Subject: LFPCN41229- Alternative Assembly Location Approval

Product/Process Change Notice (PCN)

PCN#: LFPCN41229 **Date:** Mar 30th 2015
Product Identification:
Littelfuse TVS DO-214AA, DO-214AC package
Implementation Date for Change:
July 1st 2015

Product Qualification Report

SMA/DO-214AC Marking

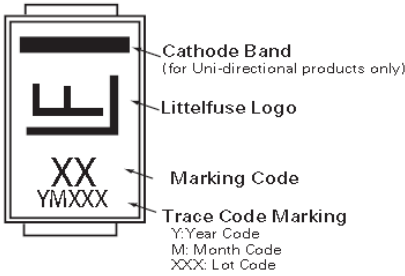
Will change the trace code marking from YMXXX to YM6XX and number 6 is the outsource code.

2. Process change

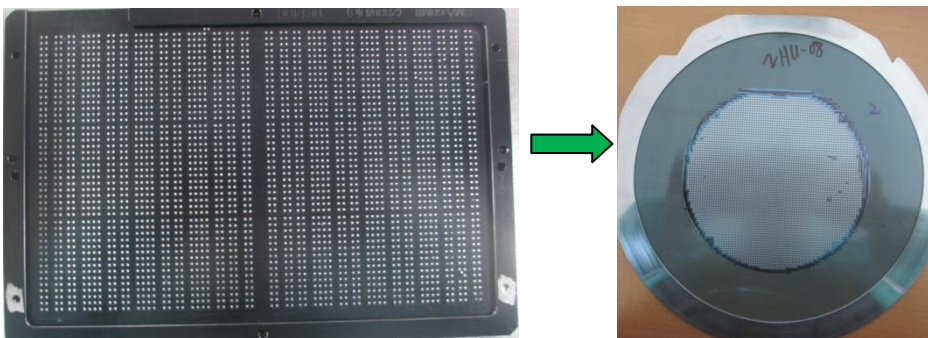
2.1. The method loading method will be changed to adapt outsource process, so the dicing and soldering process is different

2.2. The outside plating in outsource is racking plating.

3. Packing

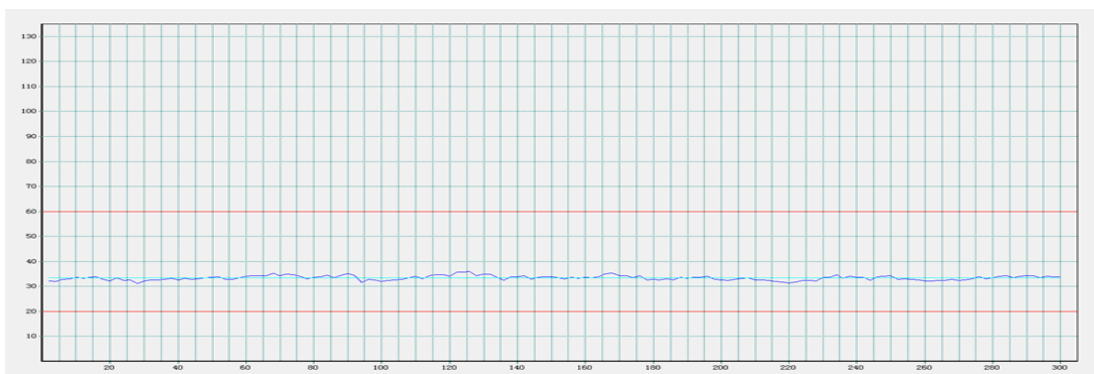
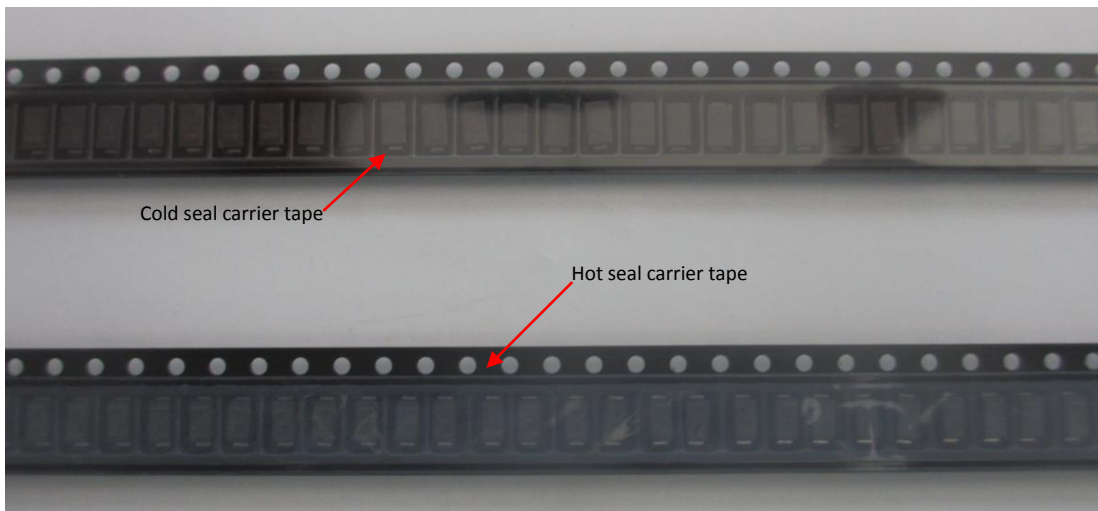
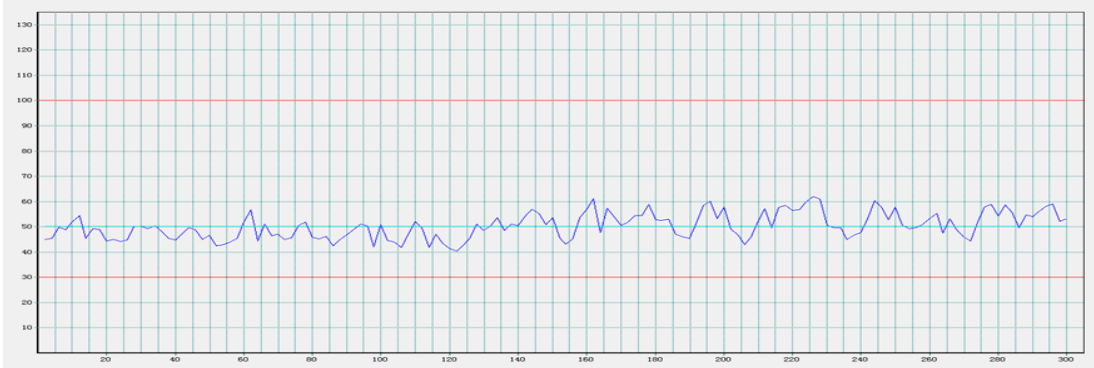
3.1. The carrier pull force also change from 20~60g to 30~100g because Change SMA/DO-214AC series carrier tape to hot seal carrier tape.

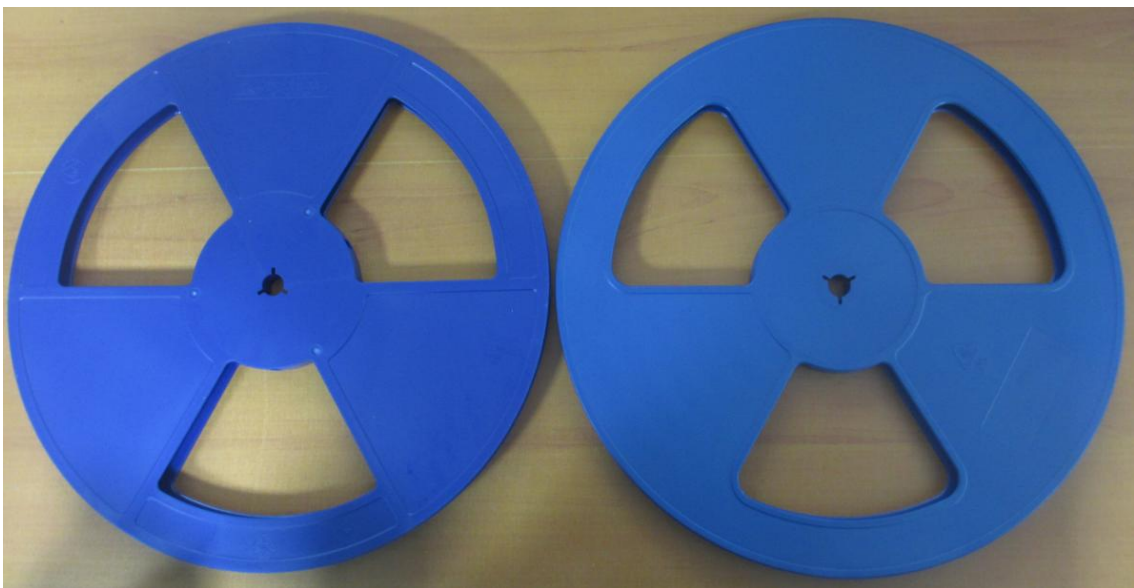
3.2. The blue plastic tape will change to outsource tape and the dimension will not change.

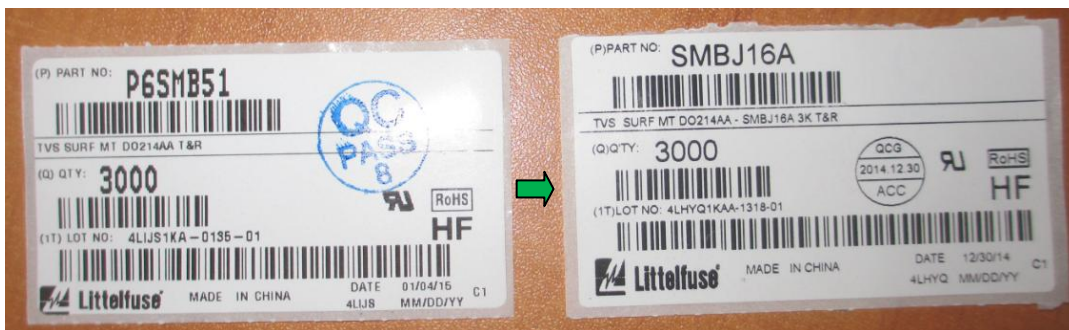
3.3. The label on internal pizza box is changed and print the QC signet on the label.
